Department of Planning, Housing and Infrastructure

Our ref: Greenwich Hospital Redevelopment Detailed Design (SSD 13619238) and
Redevelopment of Greenwich Hospital (Concept) Modification 1 (SSD 8699 Mod 1)

Subject: Response to Greenwich Hospital Redevelopment Stage 2 (SSD-13619238 and SSD-8699-Mod-1) Request for Comment – Recommended Conditions of Consent

Attachment A

Figure 2: Revised APZ (base source: travers bushfire & ecology)

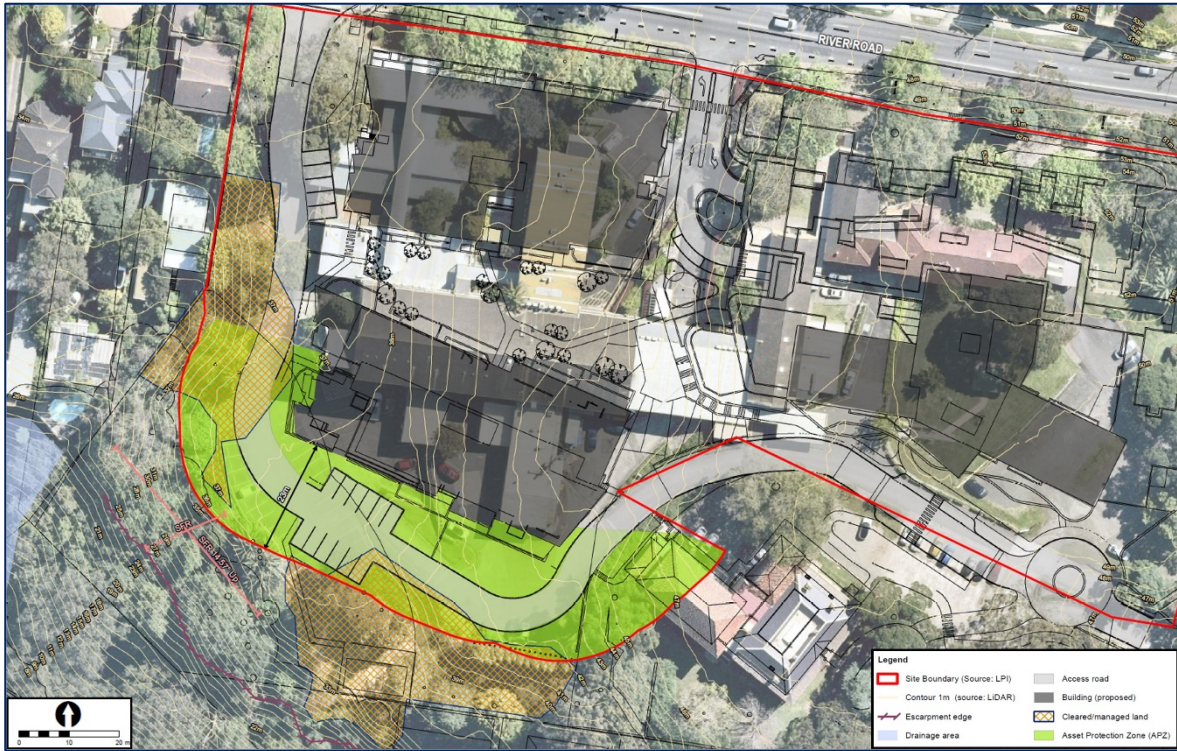
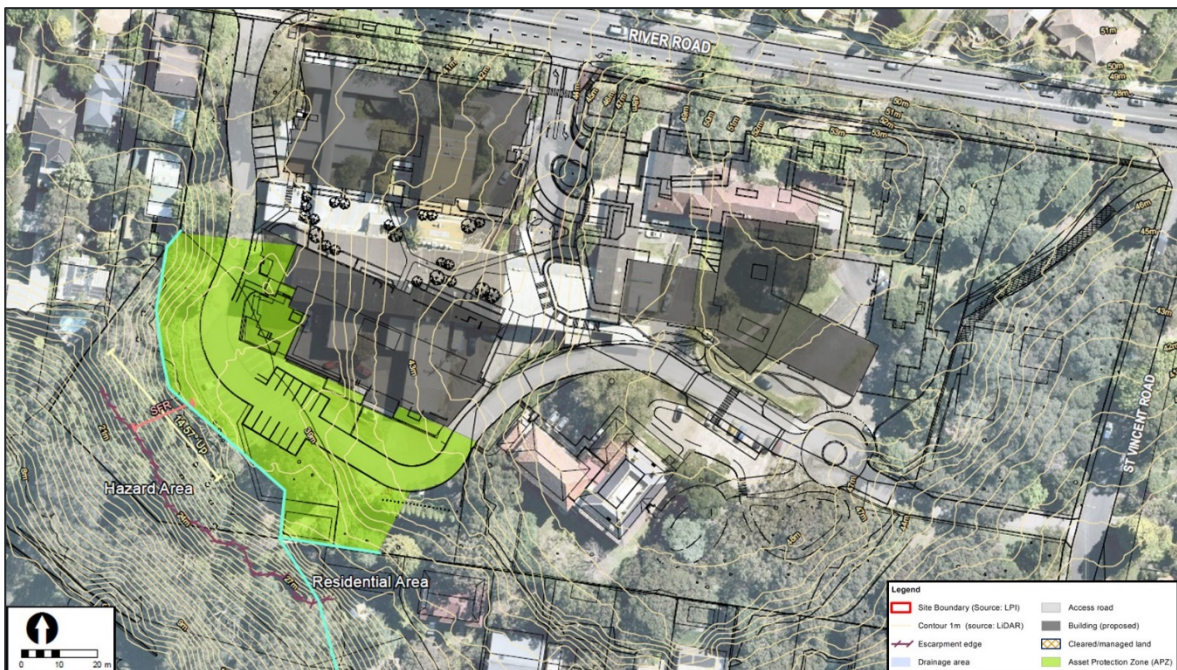
Condition E45 – Question to Department: the provided landscape plans indicate that there would be trees touching/overhanging the buildings and canopies would not be separated by 2.5m. Has the Department assessed the proposed landscaping against the IPA requirements, including confirmation of the 15% canopy cover (noting the whole site is 30.9%) and the 10% ground cover?

The bush fire response (**Appendix C**) also seeks to extend the APZ to cover an area of cleared and managed land between the formerly proposed APZ and the adjoining resident to the south (see **Figures 1 and 2**), which was not previously noted due to dense vegetation screening. The revised APZ seeks to manage impacts on the adjoining dwelling to the south to ensure that the bush fire risk was no closer to that dwelling than it was previously. The bush fire consultant also recommends that vegetation management protocols be established for the site that ensures ongoing mowing, thinning, pruning and excess fuels removed as per fuel controlling measures outlined in *NSW Rural Fire Service Standards for asset protection zones*.

The bushfire consultant also reviewed the latest landscaping plans and confirms that the proposed landscaping within the APZ should not exceed the maximum 15% canopy cover permitted for inner protection areas.

The Department is satisfied that the landscaping is capable of meeting canopy and ground cover requirements within the APZ. Changes to conditions in **Attachment B** have been included to clarify that only the APZ identified in the latest bushfire response be managed in perpetuity as an IPA and not the entire site. An additional condition has been included to update the VMP with planting details, APZ measures and vegetation protocols for the remainder of the site.
